Office Action Summary

10/542,374

DETAILED ACTION

Fig. 1

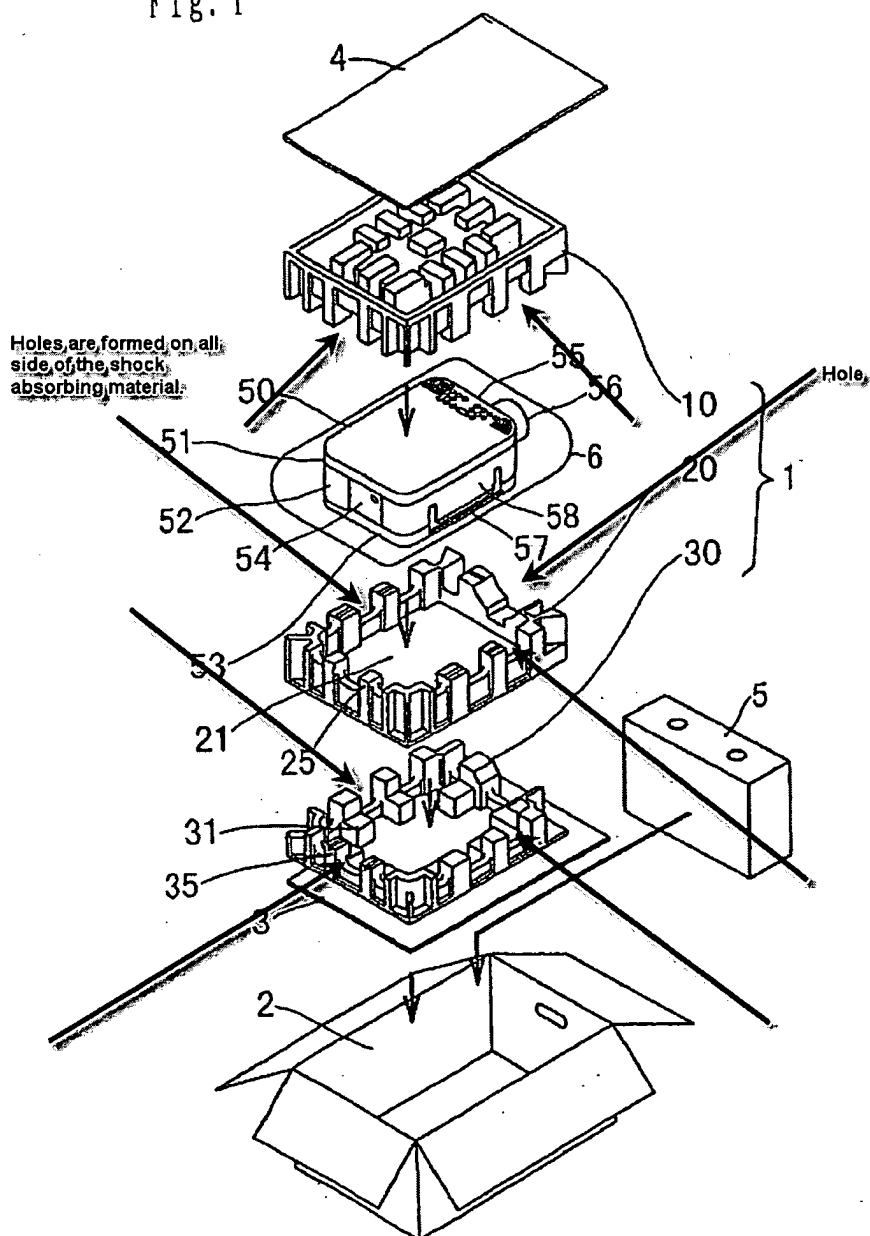
Accordingly, the examiner maintains that figures 1-8 of Koike clearly show that holes are formed on all sides of the shock absorbing material. For example, figure 1 shows opening spaces between projections, on all sides, of each of shock absorbing materials (10, 20, 30).

Attached is the copy of Fig. 1 of Koike reference, and the arrows provided pointing to the openings (or holes) on all side of the shock absorbing materials (10, 20, 30), and each shock absorbing material is a single pad.
